TRANSMITTAL SHEET
HC-ASB-61-316
Propeller - Hub Inspection

June 26, 2009

This page transmits a revision to Alert Service Bulletin HC-ASB-61-316.

This revision is issued to change the following in the Alert Service Bulletin:

Eddy Current Mounting Flange Inspection Area
Figure 1

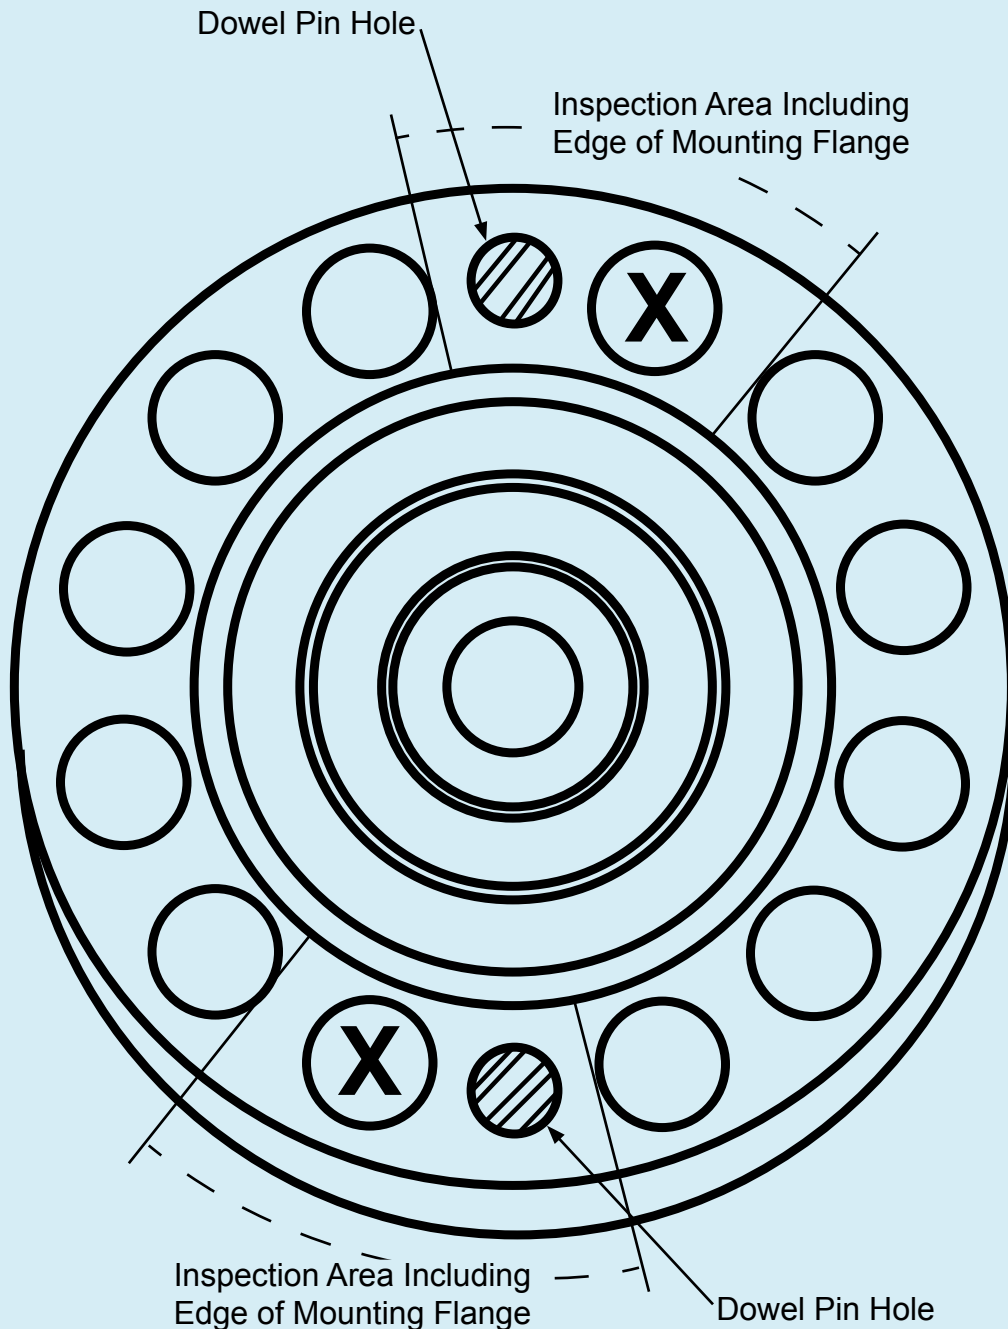
- This revision clarifies that all propeller hubs must be eddy current inspected at each propeller overhaul.
- This revision clarifies that the stamping of the letter "K" is on the cylinder side of the propeller hub.

- (3) **Repetitive Interval** for any propeller hub installed in an HC-E4A-3()/E10950() propeller assembly and with a B-1243-1 oversize insert installed in one or both of the mounting holes specified in Figure 1 or a letter "K" stamped below the propeller serial number on the cylinder side of the hub - **Refer to Figure 1 for the inspection area:**

- (a) Perform the eddy current inspection in accordance with the Accomplishment Instructions in this Alert Service Bulletin at each propeller overhaul.

- (a) Perform the eddy current inspection in accordance with the Accomplishment Instructions in this Alert Service Bulletin every 1,000 hours.
